Program Bulletin

CUSTOMER SATISFACTION PROGRAM

SUBJECT: Transmission Dipstick Tube Fracture

MODELS: 2010-2011 Cadillac Escalade, Escalade ESV, Escalade EXT
2010-2011 Chevrolet Avalanche, Silverado, Suburban, Tahoe
2010-2011 GMC Sierra, Yukon, Yukon XL
Equipped with Active Fuel Management

2906255

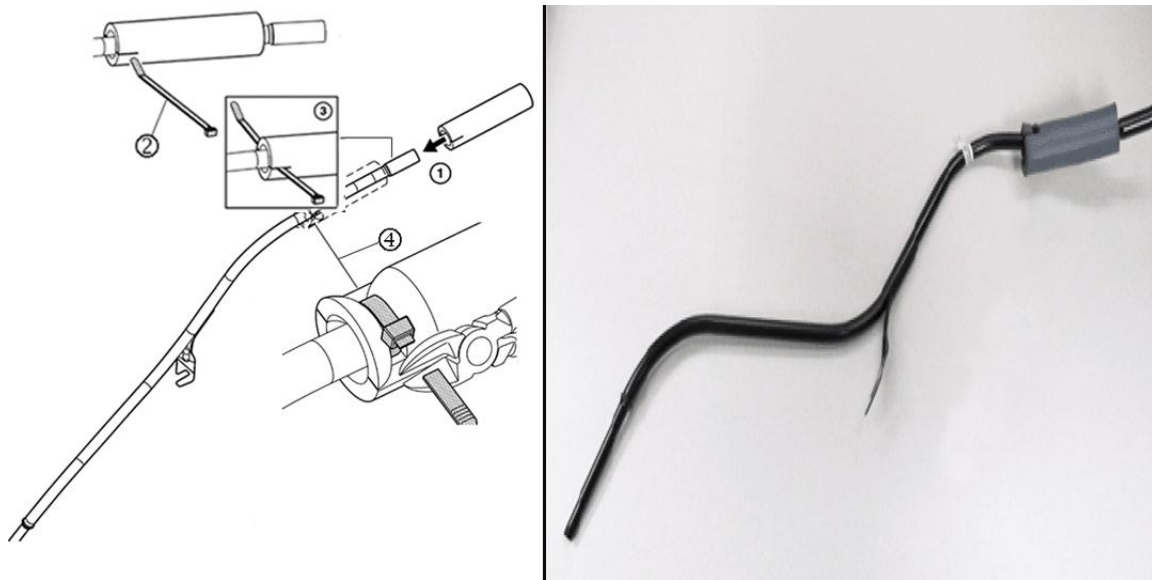
3. Grasp the transmission filler tube with your thumb and first two fingers of your right hand. Your thumb should be on the passenger side of the transmission filler tube and parallel to the filler tube.

4. Using only your thumb and the first two fingers of your right hand, force the transmission filler tube toward the driver's seating position and then back to the passenger's front wheel two times.

5. Determine if the transmission filler tube is damaged. An undamaged transmission filler tube will move less than two inches and spring back to its original position, while a damaged transmission filler tube will move greater than two inches and will not spring back to its original position. A damaged transmission filler tube will likely crack during this inspection.

- If the transmission filler tube is not damaged, proceed to Step 6.
 - If the transmission filler tube is damaged, replace the transmission filler tube. Refer to *Transmission Fluid Filler Tube and Seal Replacement* in SI.
